Enclosure 1

COLA will be revised as shown in this enclosure. These mark-ups are based on COLA Rev. 6 and replace those provided in RAI 03.07.01-29, Supplement 1 in their entirety.

3H.10 STP 3 & 4 Resolution of Issues with Subtraction Method of Analysis Identified by DNFSB

Figure 3H.6-22: Broadened FRS in E-W (X) Direction at the RSW Pump House Roof (Elevation 50 ft MSL)

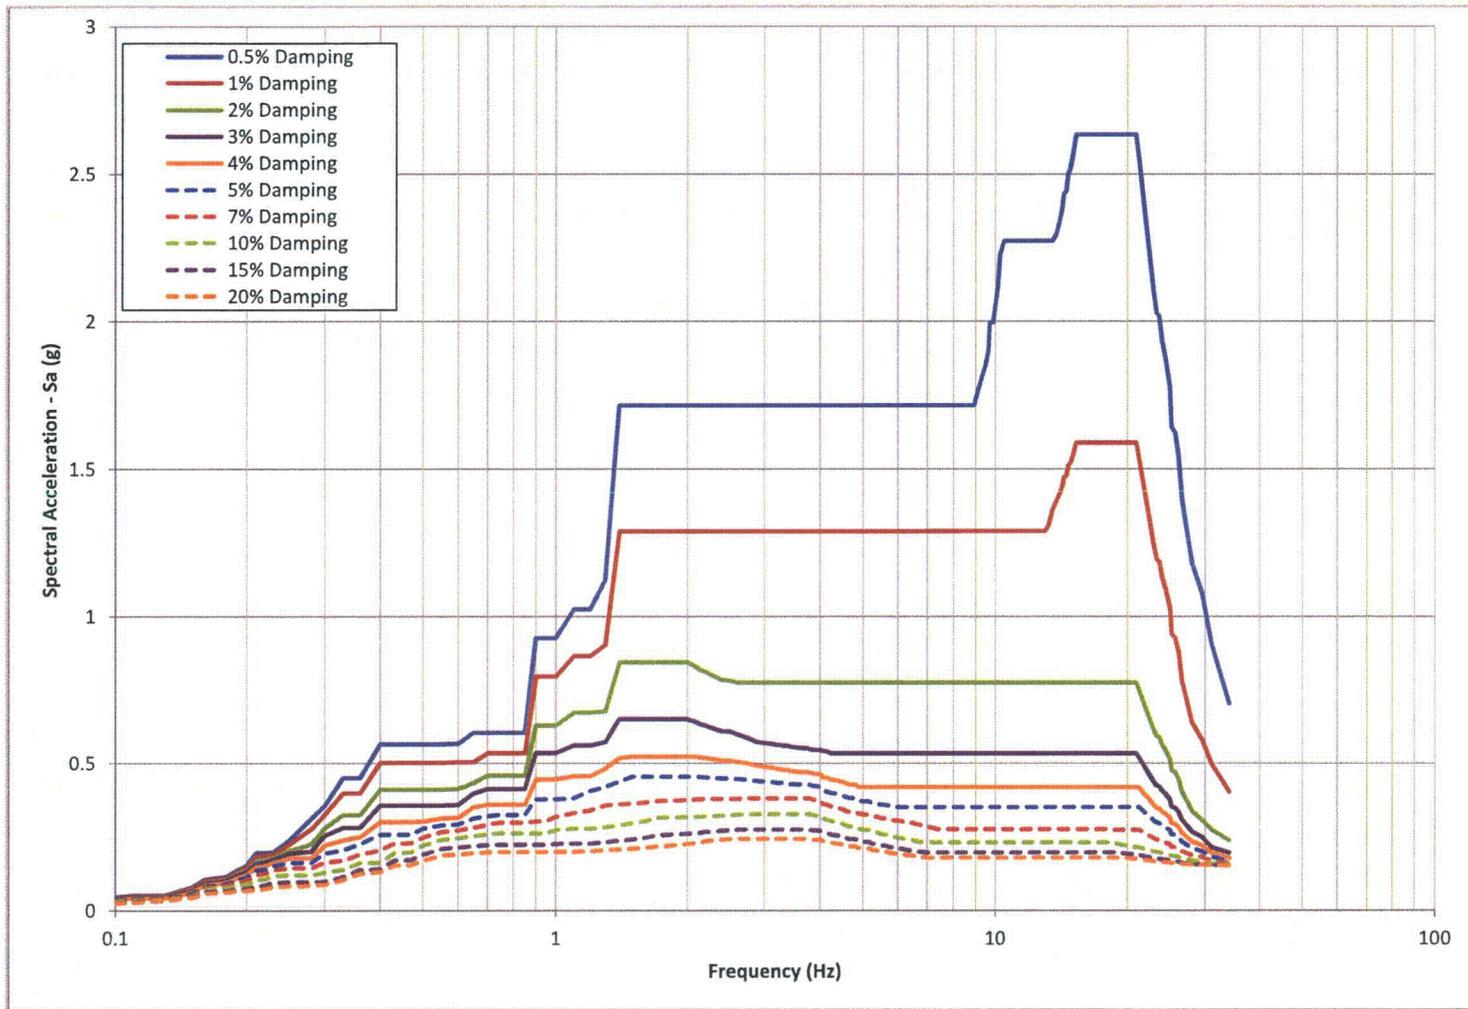
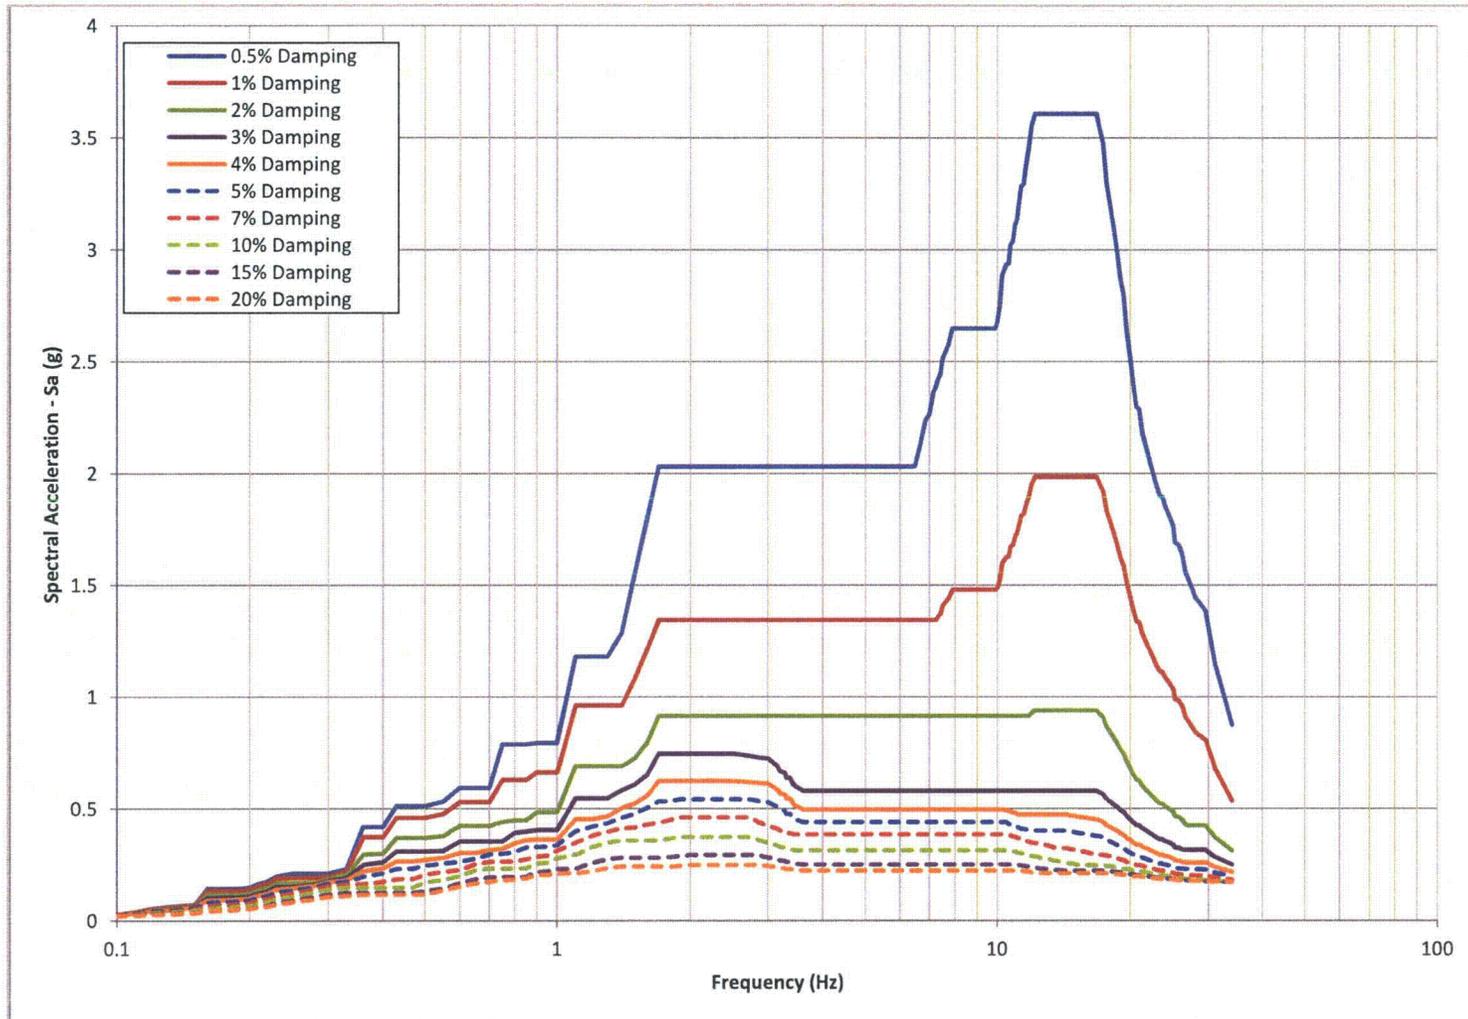
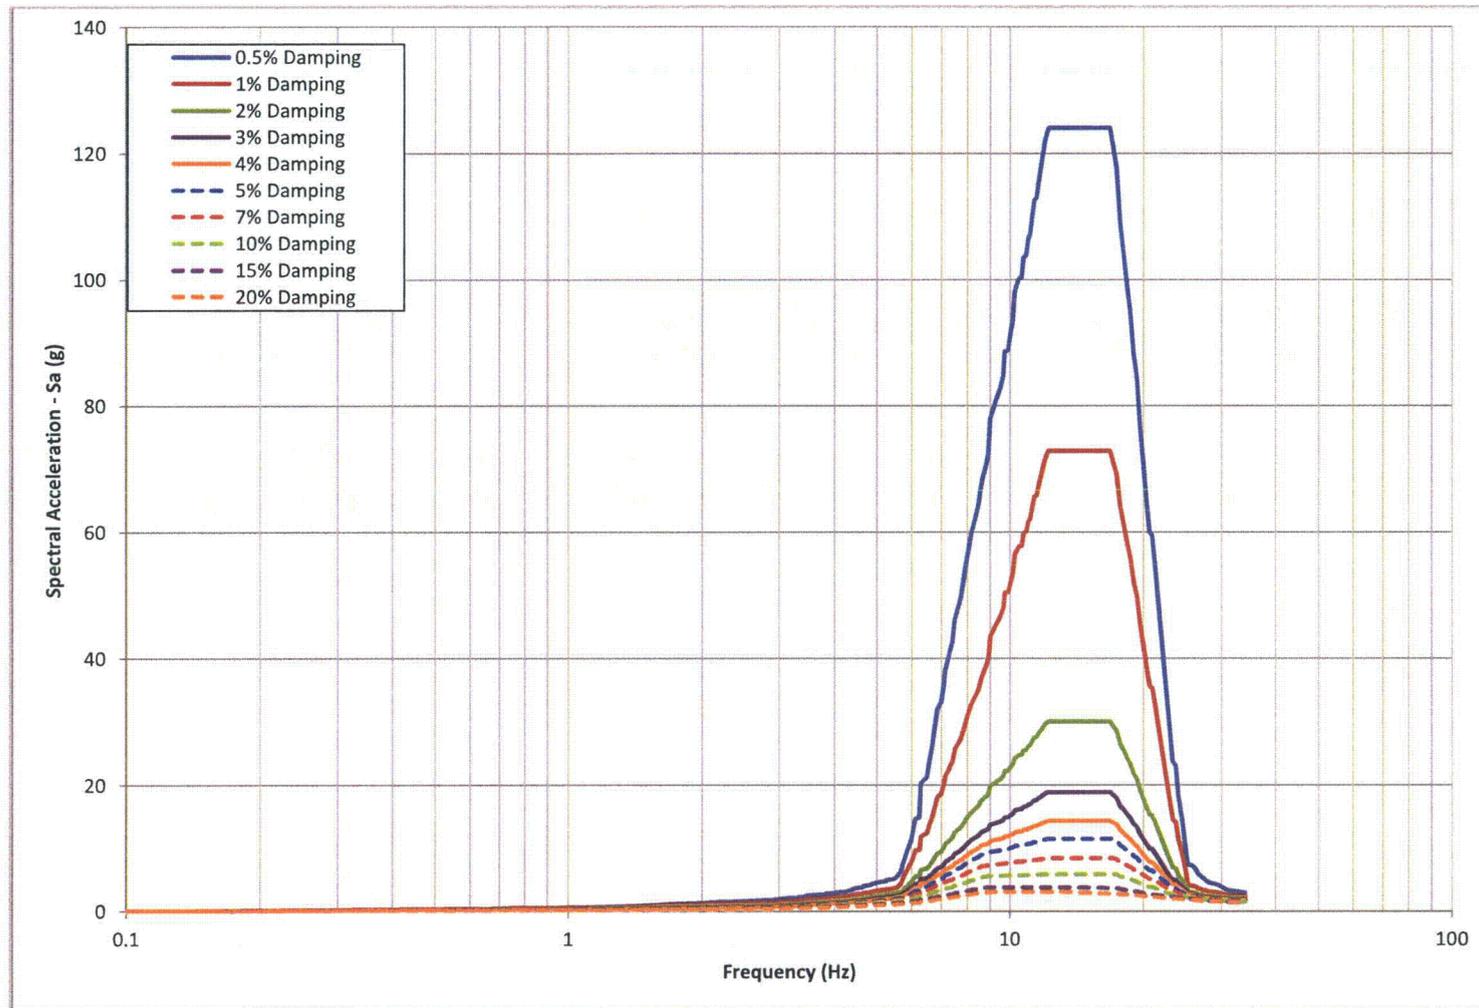
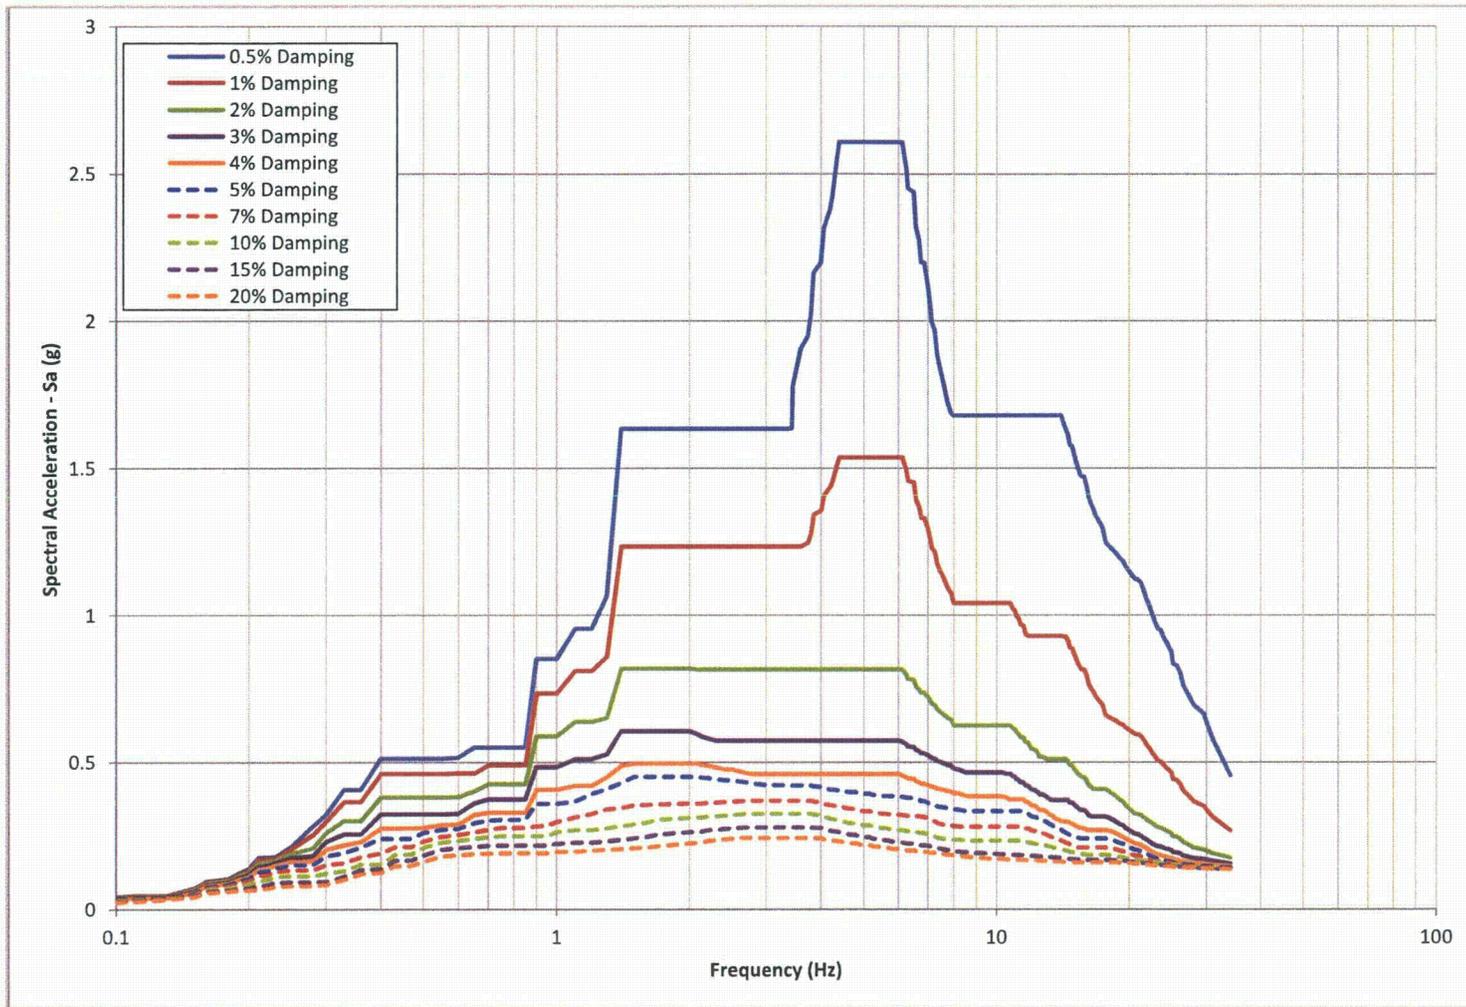
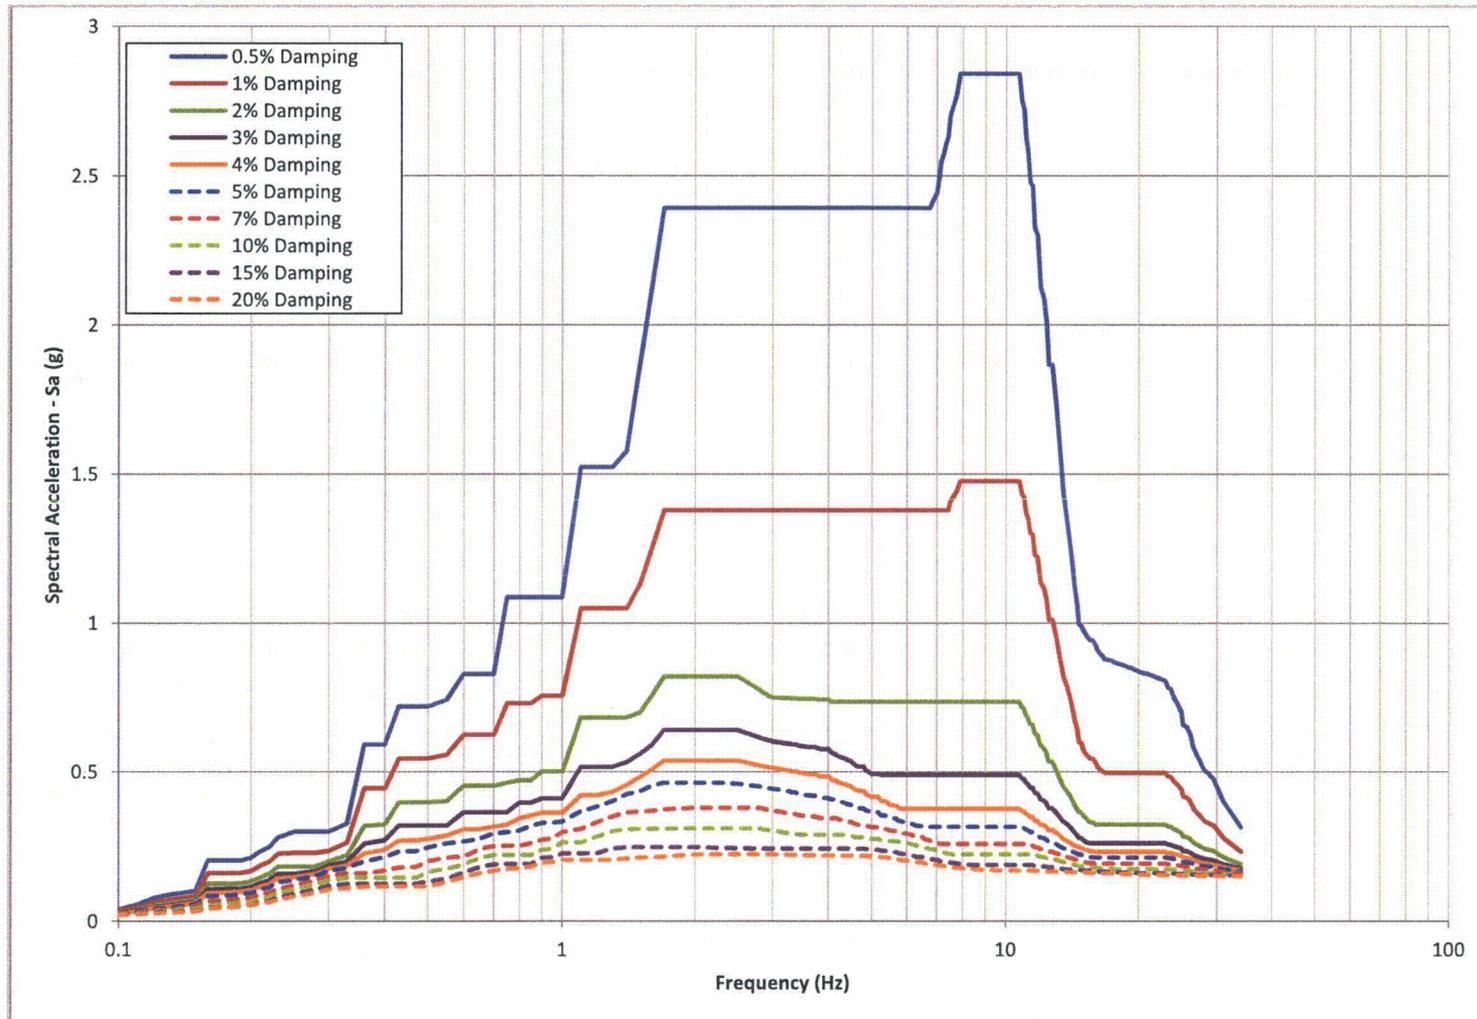
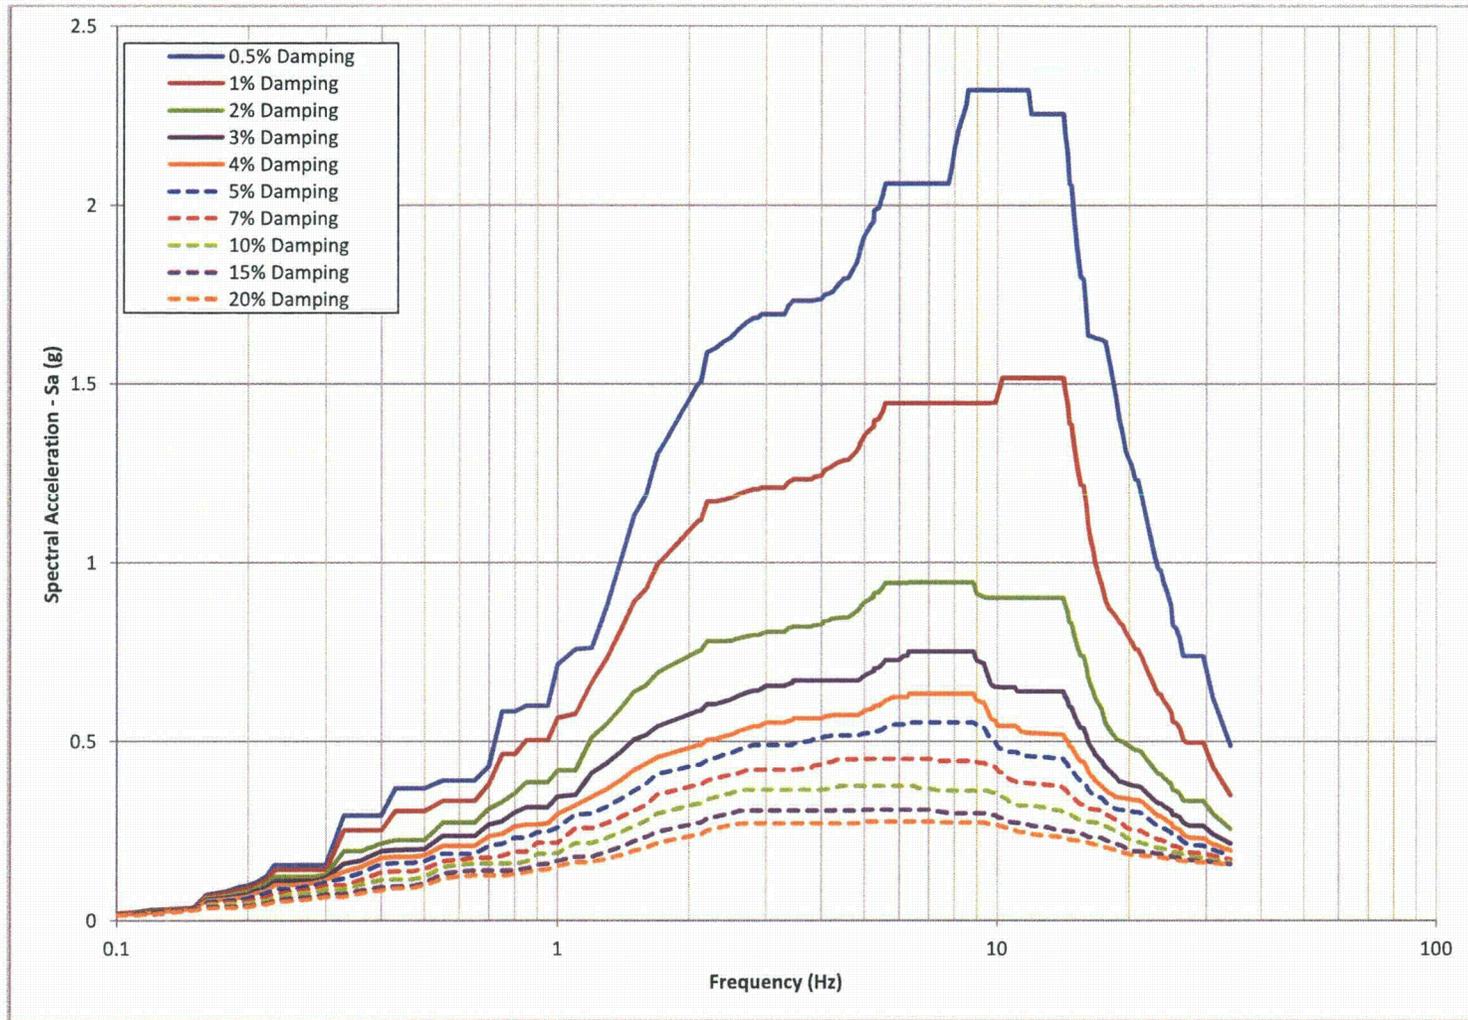
Based on the results of the above refined SSI analyses, and additional structural mesh sensitivity analyses, envelope modification factors were determined for increase of the following in-structure response spectra obtained from the SSI analyses described in Section 3H.6.5.2.4 and 3H.6.5.2.4.1. were modified by multiplying them with the modification factors shown in Table 3H.6-17. Then, the results of the full and empty basin analyses were enveloped.

- Vertical direction spectra at the center of the Pump House Roof
- Vertical direction spectra at the center of the Pump House Operating Floor
- Vertical direction spectra of the Cooling Tower Walls
- Out-of-plane horizontal spectra of the Basin Walls

In response to issues with the subtraction method of analysis identified by the Defense Nuclear Facilities Board (DNFSB) discussed in Section 3H.10, the SSI analysis for the upper bound in-situ soil case was repeated for both full and empty basin cases using the modified subtraction method of analysis. Also, in these analyses the groundwater table was changed to 6 ft below grade. Based on comparison of the resulting response spectra from these analyses to those from the subtraction method of analysis additional modification factors were determined for increase of in-structure response spectra from the subtraction method of analysis to account for the effect of using the modified subtraction method. The product of these modification factors and those described in Section 3H.6.5.2.4.2 as shown in Table 3H.6-17 were used to increase the in-structure response spectra described in Sections 3H.6.5.2.4 and 3H.6.5.2.4.1. Then, the results of the full and empty basin analyses were enveloped.

The final in-structure response spectra are shown in Figures 3H.6-16 through 3H.6-39.

The final in-structure response spectra are shown in Figures 3H.6-16 through 3H.6-39.
